### Richmond Design Review Panel

### A2871 Greggs Bakery

Project number A2871 Greggs Bakery, Twickenham Project title Document title Design and Access Statement London Square Developments Ltd Client Document status Planning Submission 05 August 2022 Date of issue Chloe Simons, Architectural Assistant Prepared by Ed Sharland, Associate Director Checked by

### Overlooking & privacy

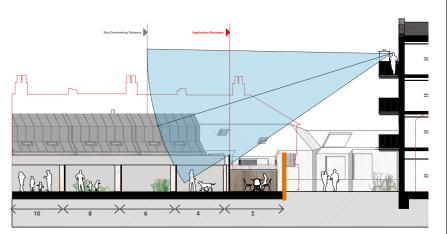
Fourth storey and balconies to the western end of Building F could have a negative impact and potential overlooking.

A full review of overlooking has been undertaken on these properties. The current proposal does not overlook existing windows, but does partially overlook the gardens of 4 Gould Road. Overlooking of gardens is a common condition within the area and within London and was considered acceptable by officers as part of the previous application. It is also important new apartments are provided with balconies where possible to meet London Plan.

However the design incorporates the following changes to reduce this perceived overlooking to benefit the existing owners of the gardens.

- Overlooking to neighbouring gardens minimised by garden of number 2 Gould Road and proposal to increase height of existing perimeter wall at site application boundary;
- Balcony railings amended to blades directing views towards the river providing residents with additional privacy and reducing overlooking from those sitting on the balcony or within the rooms.

# Summary of post-submission elevation and massing amendments to Building F

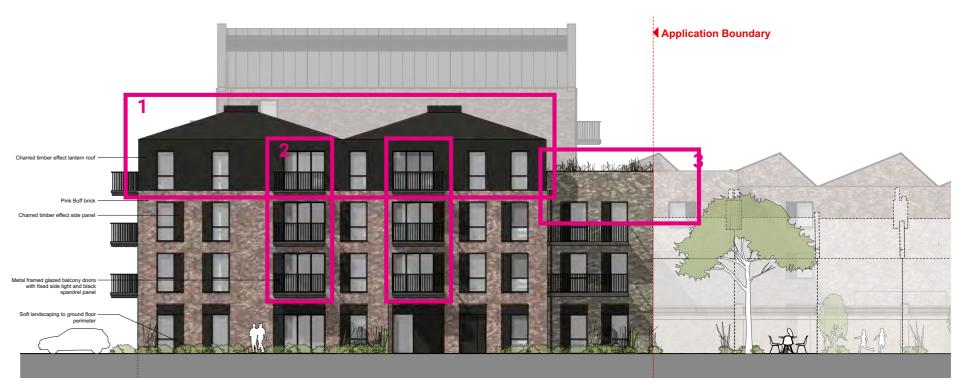
- Concerns over the massing at the junction of Gould Road and Crane Road in relation to existing terraces and overlooking from the roof gardens in Building F;
- Review the lantern roof and look at the option of a flat roof instead; not convinced of the darker tone.

The roof of Building F appears over-heavy and appears to emphasise the upper-storey finish.

Design changes made following DRP & pre-application include:

- 1. Top floor and roofscape reduced angle and change of material;
- 2. Balcony design amended;
- 3. Massing reduced by lowering the top floor parapet and the communal roof terrace omitted.

Existing routes and bridges

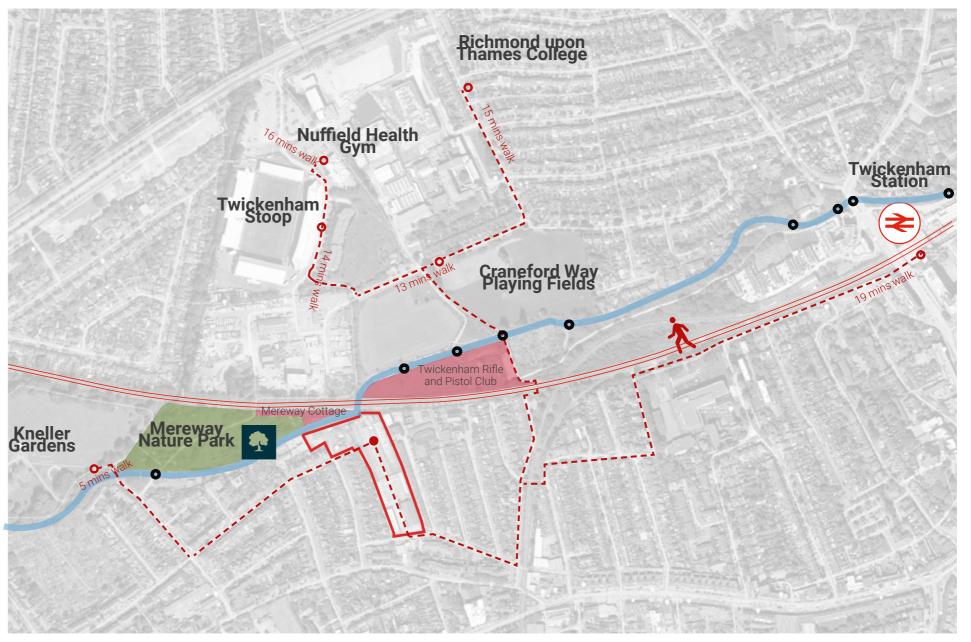
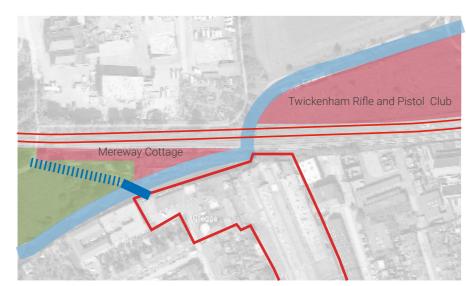
In response to comments made at the public consultation we have looked at the possibility of facilitating a new pedestrian crossing over the River Crane as part of the design process.

Due to the presence of the river and railway, providing a new pedestrian bridge is not a straight forward proposal. This is further complicated by the private land owned by Twickenham Rifle and Pistol Club and Mereway Cottage.

Option 1 would require a bridge to go over both the railway line and river. This would require the bridge to go up a significant height and traverse a long distance. It would also need to be approved by Network Rail.

Option 2 requires a diagonal span to the Mereway Nature Park. This is dependent on ground conditions to the west and is likely to have a negative effect on the biodiversity of the nature park.

It is considered option 2 is the only feasible option for a future bridge.
